UNITED STATES PATENT AND TRADEMARK OFFICE

APPLICATION NO.	FILING DATE	FIRST NAMED INVENTOR	ATTORNEY DOCKET NO.	CONFIRMATION NO.
09/802,982	03/12/2001	Stefan Karl	1200.473	6932

Office Action Summary

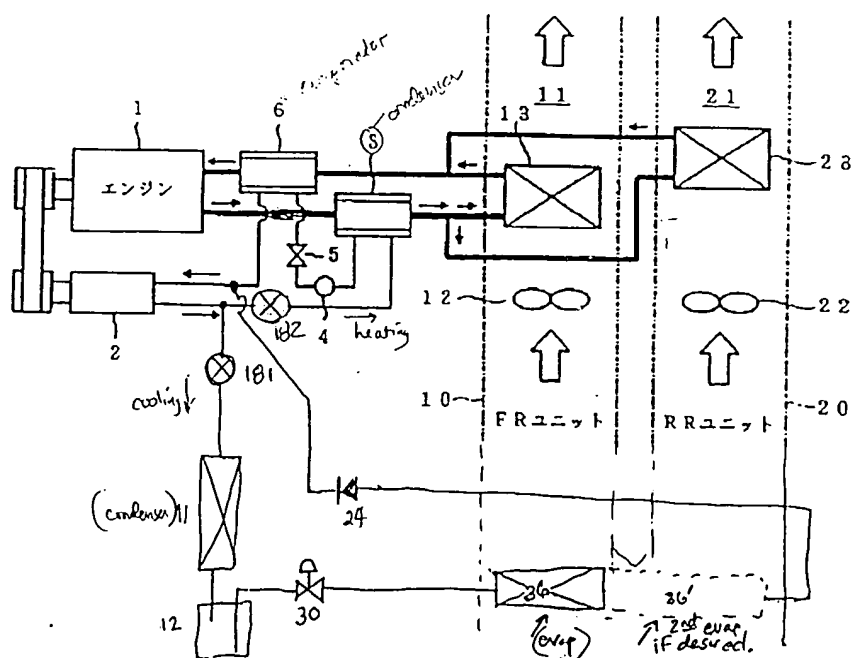
Claims 1, 2 and 10-14 are rejected under 35 U.S.C. 103(a) as being unpatentable over JA 10-76837 in view of Enomoto (Fig 8) and either Whalen or Momose (JA'134)

JA '837 shows a refrigerant system for beneficially increasing the heating effect of a liquid based heating system. It has no ability to cool the compartment in hot weather. The compressor 2 is known to be the most costly component of automotive refrigerant system.

Enomoto teaches in Figure 8 a refrigerant based heater circuit (182,13,37, 15) and a refrigerant based cooler circuit (181,11,12,30,36 and 24) connected in parallel across the output and inputs of the compressor 10.

To have added a refrigerant based cooler circuit (as described above) to JA'837 to give the capability of cooling in the summer as well as heating in the winter would have been obvious to one of ordinary skill in climates where air conditioning was needed to preserve occupant comfort. Appropriate valves (181,182) on the discharge

side of the compressor would be necessary to separately activate the heating and cooling systems. The modification is shown below.

Regarding claim 10, see element 24 in the sketch. Regarding claim 11, see elements 5 and 30. Regarding claims 13 and 14, note Enomoto shows an internal combustion engine and discloses as a substitute an electric motor (col. 5, last line).
